## SERVICE BULLETIN 06-28Open-1

MODEL(s) AFFECTED: 28 Open HIN #101-170

BULLETIN SUBJECT: Bilge Pump Thru-Hull Placement

**Mid & Aft Bilge  
Vented Loop Installation**

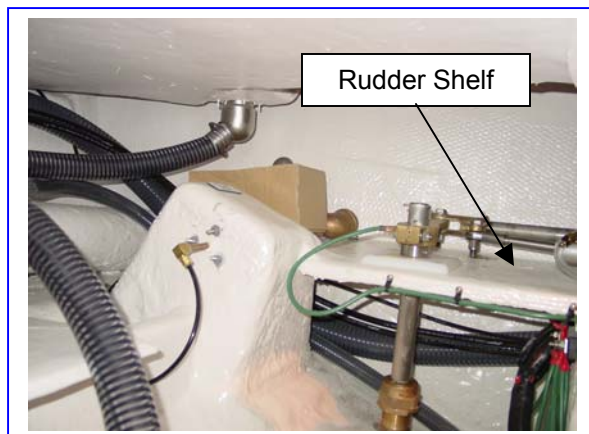
Step 1: Disconnect hose from Mid Bilge Discharge fitting.

Step 2: Locate Vented Loop (Item 1) on starboard side of transom as high as possible & attach with Screws (Item 2).

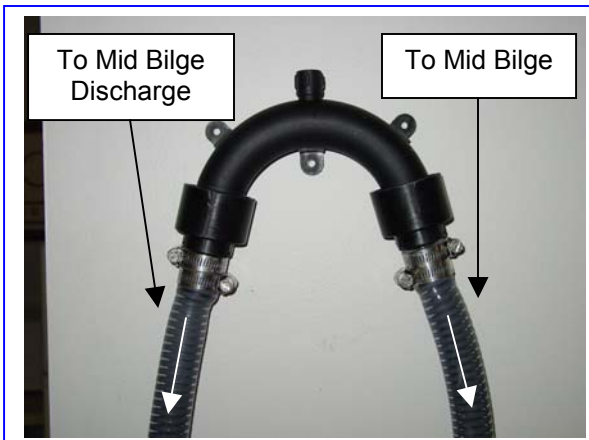
Step 3: Drill a 1 1/2" hole thru rudder shelf.

Step 4: Run hose from Mid Bilge Pump up thru hole & trim hose to fit & connect to Vented Loop with Clamps (Item 4).
